<b>Tollway Standard Drawing Revisions</b>
---

<b>Section H</b>	<b>Roadway Lighting and Electrical</b>		
	<b>Standard</b>	<b>Modification Summary</b>	<b>Effective 11/01/2012</b>
	<b>H1</b>	<b>Light Standard</b>	
		Added Controller Number	
	<b>H3</b>	<b>Wingwall Conduit Details</b>	
		Revised junction box from cast iron to stainless steel material	
		Revised junction box size to 20" x 12" x 7"

STANDARD H1-02

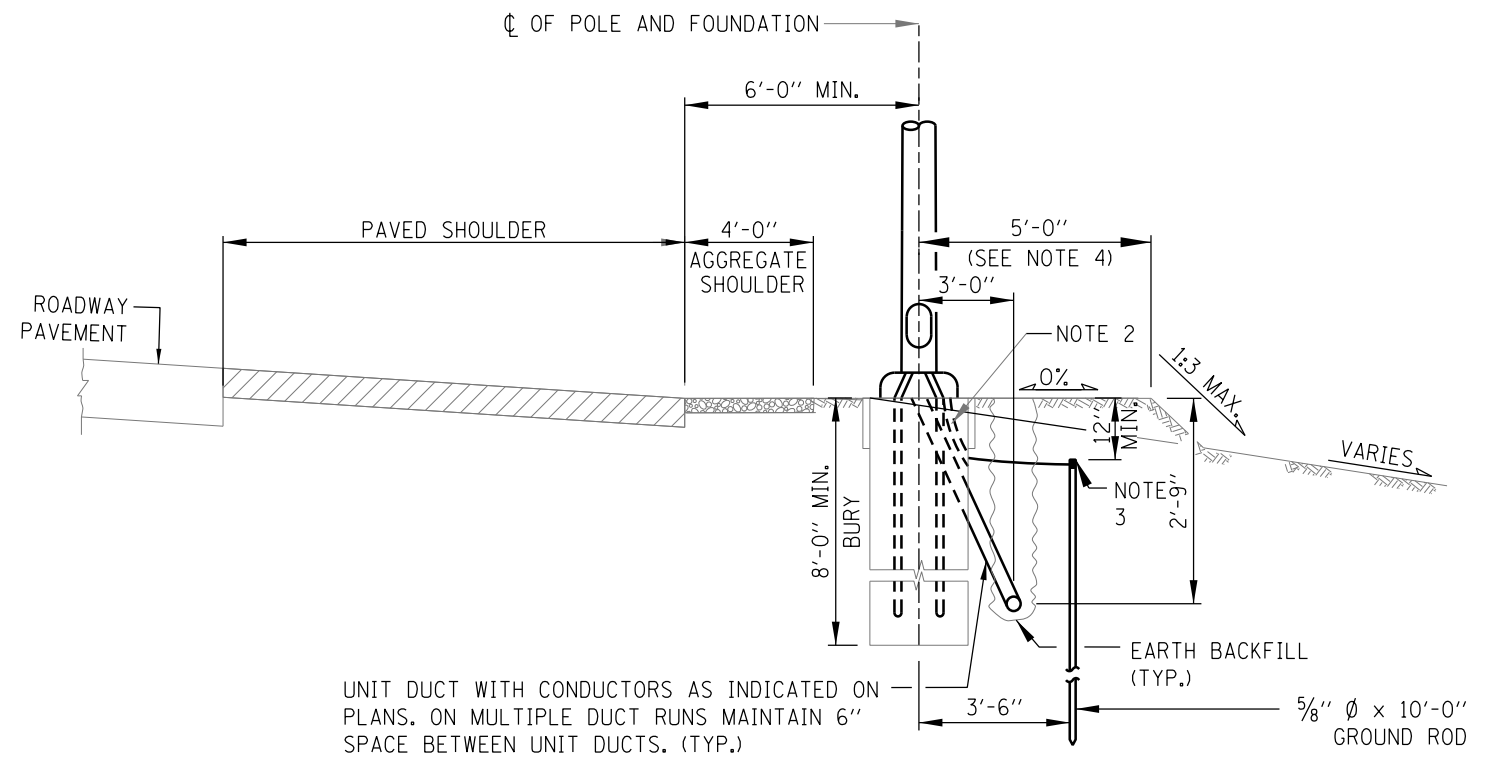
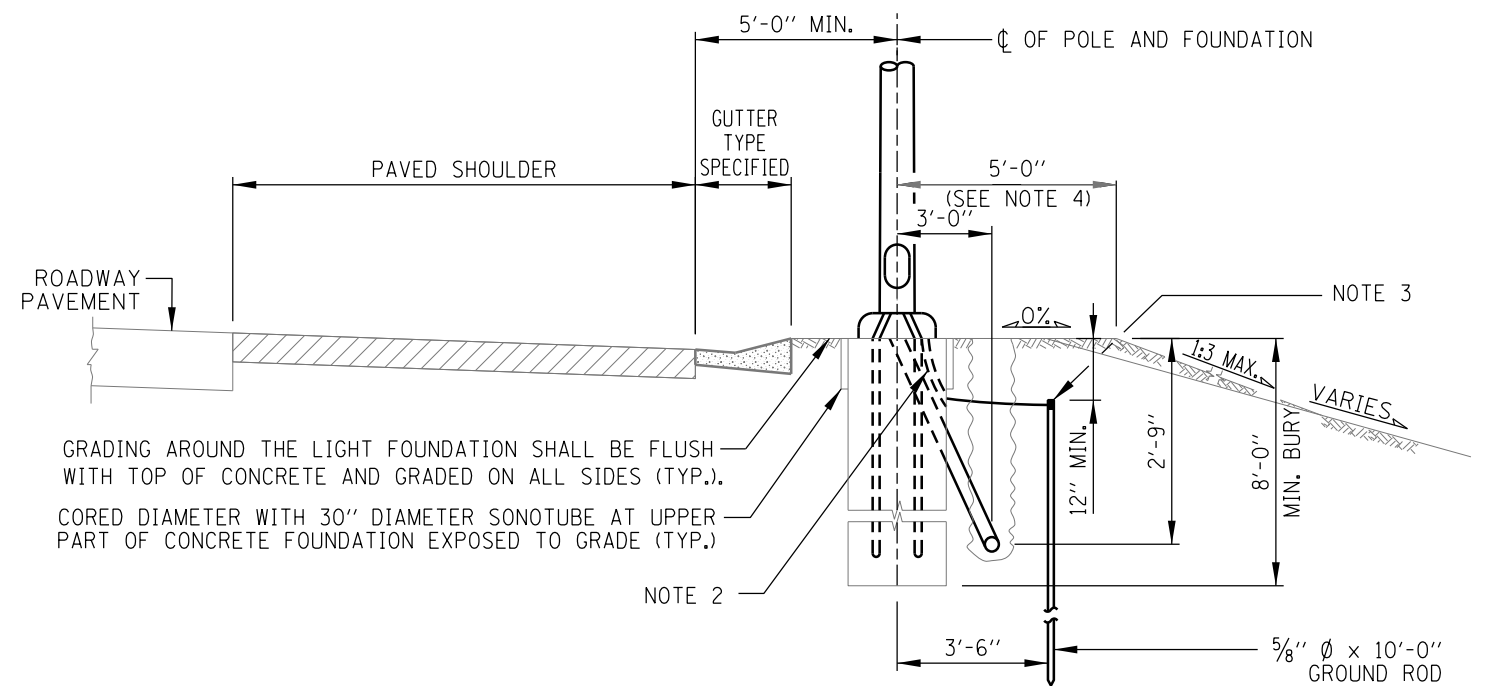
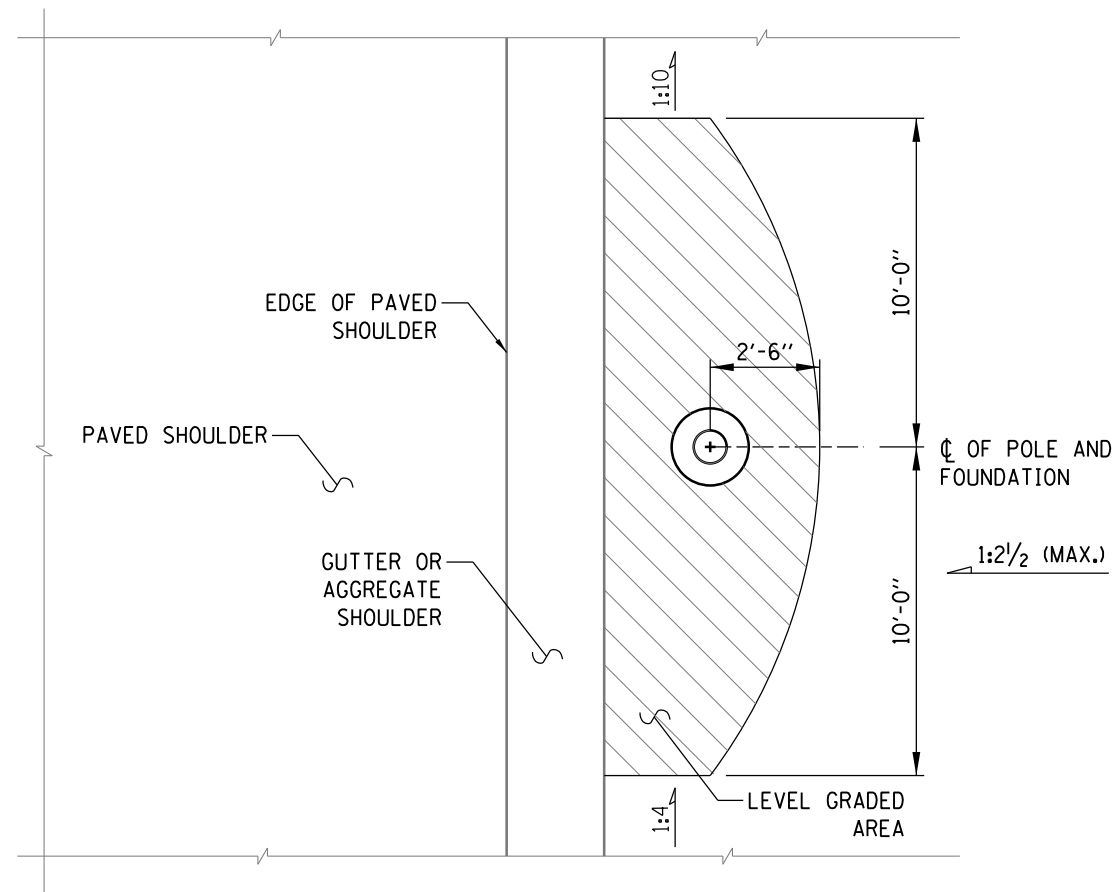
DATE	REVISIONS
2-7-2012	MODIFIED FOUNDATION DETAILS, REVISED NOTES
11-1-2012	ADDED CONTROLLER NUMBER

WINGWALL CONDUIT DETAILS

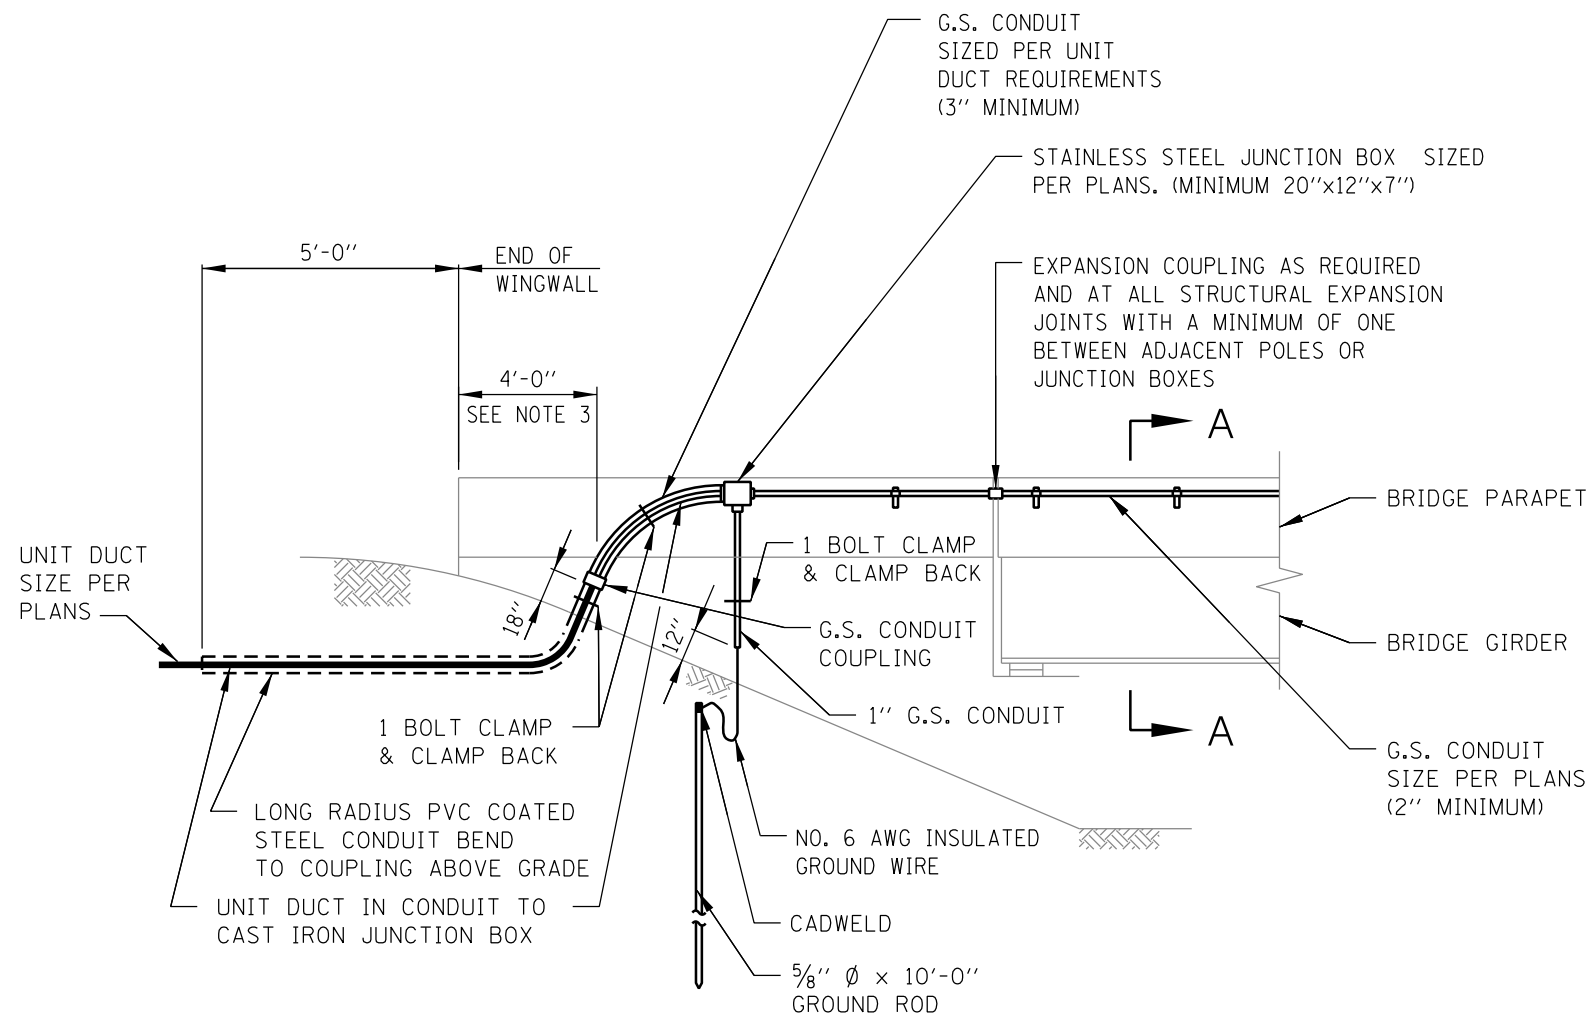
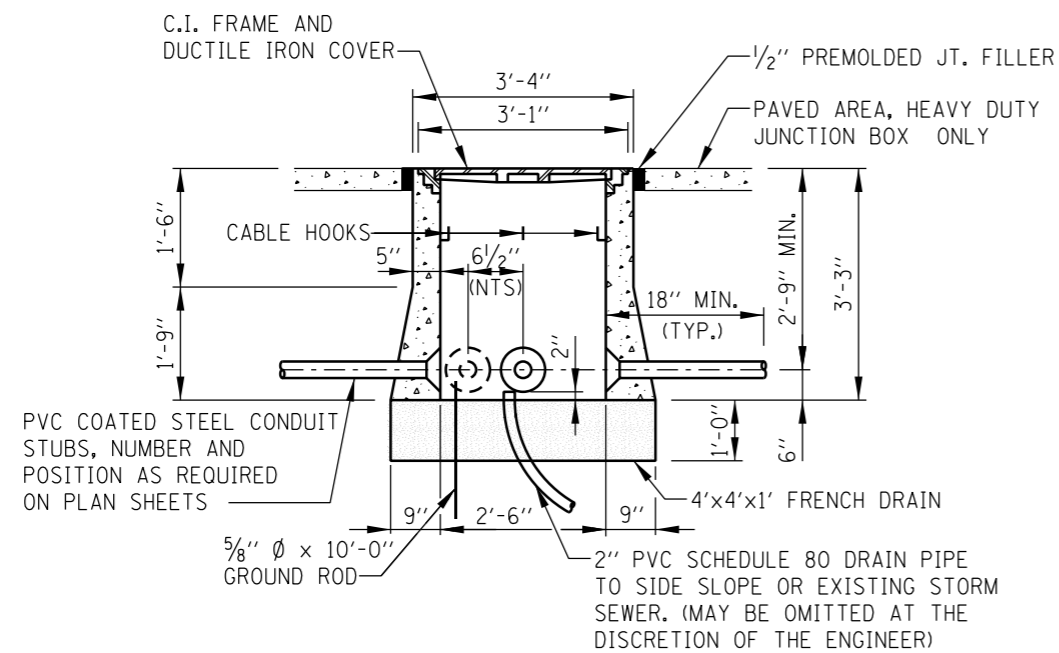
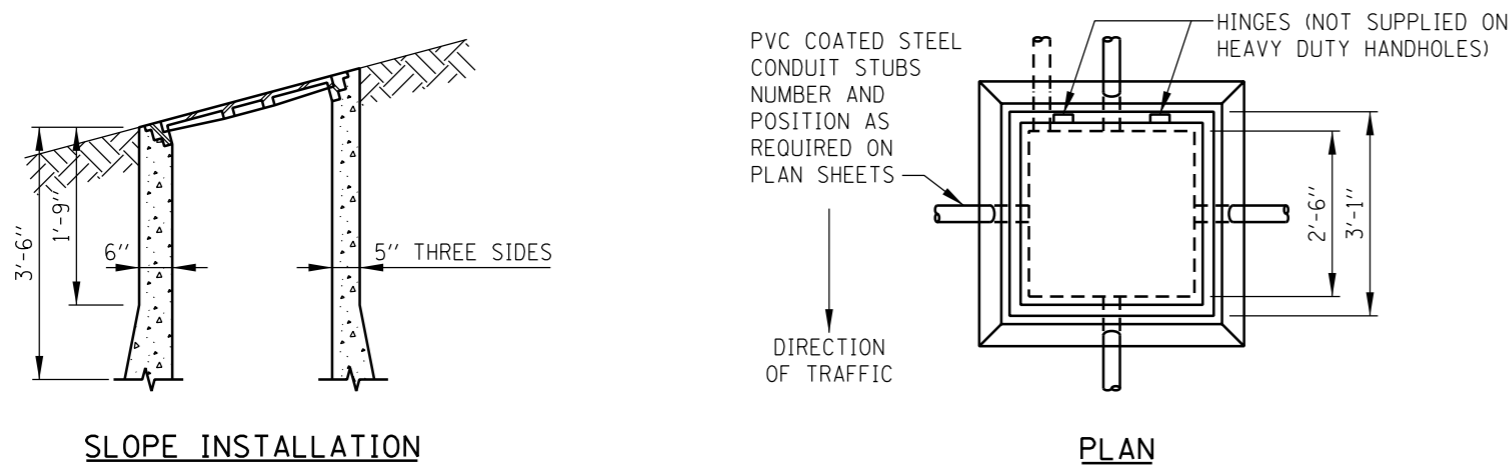
DATE	REVISIONS
2-7-2012	REVISED NOTES
11-1-2012	REVISED JUNCTION BOX
